FERNDELL PARK SUBDIVISION, RESUBDIVISION OF LOT 2

The purpose of this application is to subdivide a legal lot into two lots of records.

FERNDELL PARK SUBDIVISION, RESUBDIVISION OF LOT 2

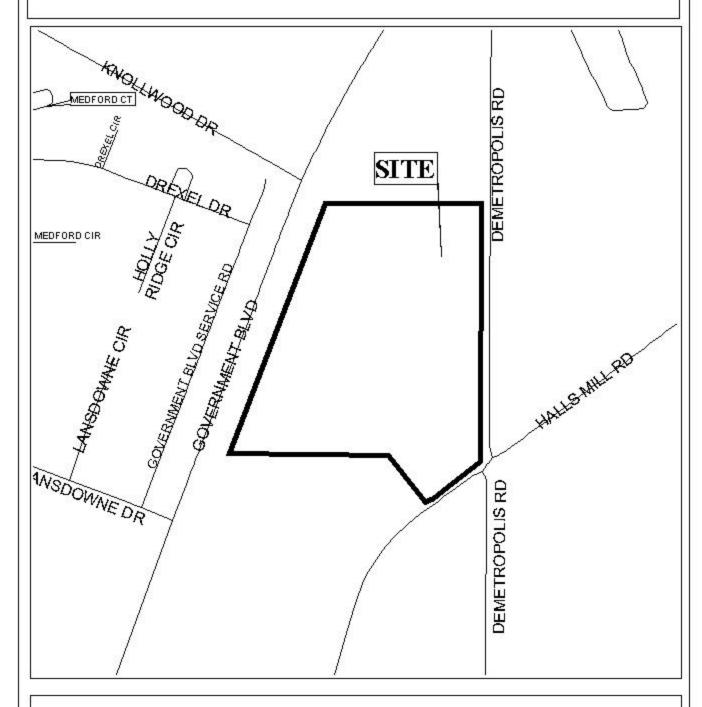
The plat illustrates the proposed 2 lot, $23.7 \pm$ acre subdivision which is located at the Northwest corner of Demetropolis Road and Halls Mill Road, extending to the East side of Government Boulevard. The subdivision is served by public water and sanitary sewer.

This section of Demetropolis Road is not shown as part of the major street, it is to the South of where the major street curves to the East. However, Halls Mill Road, which is shown to have a 50' right-of-way is a collector street, and as such requires a minimum right-of-way of 70 feet.

As a means of access management, a note placed on the final plat stating that the size, number and location of all curb cuts must be approved by the Traffic Engineering Department, should be required. Also of concern is the potential for cut-through traffic since Lot 1A is double fronting. Therefore, a note denying a direct connection from Government Boulevard to Halls Mill Road, should be required.

The plat meets the minimum requirements of the Subdivision Regulations and is recommended for Tentative Approval subject to the following conditions: 1) a note placed on the final plat stating that the size, number and location of all curb cuts must be approved by the Traffic Engineering Department, should be required; and 2) a note placed on the final plat stating that there will be no direct connection from Government Boulevard to Halls Mill Road.
